# UNITED STATES PATENT AND TRADEMARK OFFICE

| APPLICATION NO.  | FILING DATE | FIRST NAMED INVENTOR | ATTORNEY DOCKET NO.         | CONFIRMATION NO.       |
|--|-------------|----------------------|-----------------------------|------------------------|
| 10/685,139   | 10/14/2003  | Steve Mitchell       | 19433A-003210US             | 4489                   |

## Office Action Summary

## DETAILED ACTION

*FIG. 8*

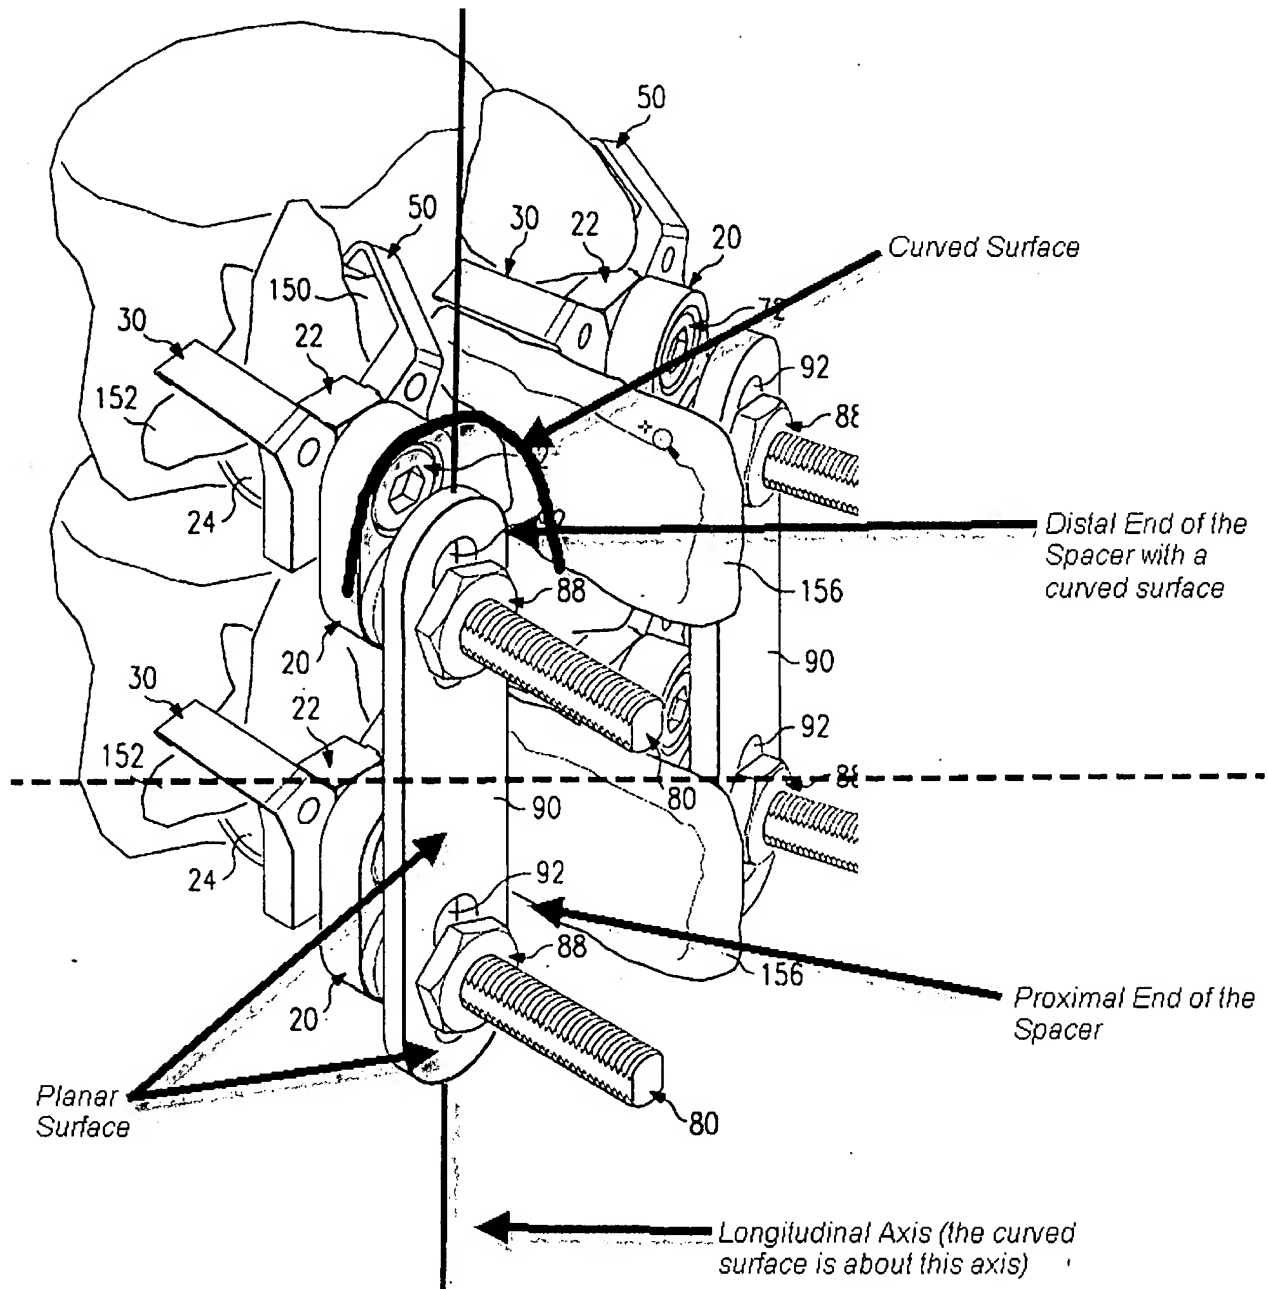
Applicant also asserts that the Lee et al. reference does not disclose a spacer with a distal end with a curved surface formed about an axis and a proximal end that is planar, wherein the axis is parallel to the plane of the proximal end. The examiner

respectfully disagrees that the Lee et al. reference does not disclose those limitations.

Below the examiner is providing marked-up figures to illustrate that the Lee et al.

reference does indeed meet those limitations.

The Spacer (ref. #90) still meets the newly added claim limitations regarding the locations and orientations of the curved and planar surfaces of the spacer as shown in the above figure. The vertical axis that runs longitudinally through ref. #90 is the axis that the surface curves around. The vertical axis runs parallel to the top and bottom planar surfaces of ref. #90. Similar is true for the second interpretation for claims 7 and 8, which refers to ref. #70 as the spacer rather than ref. #90.
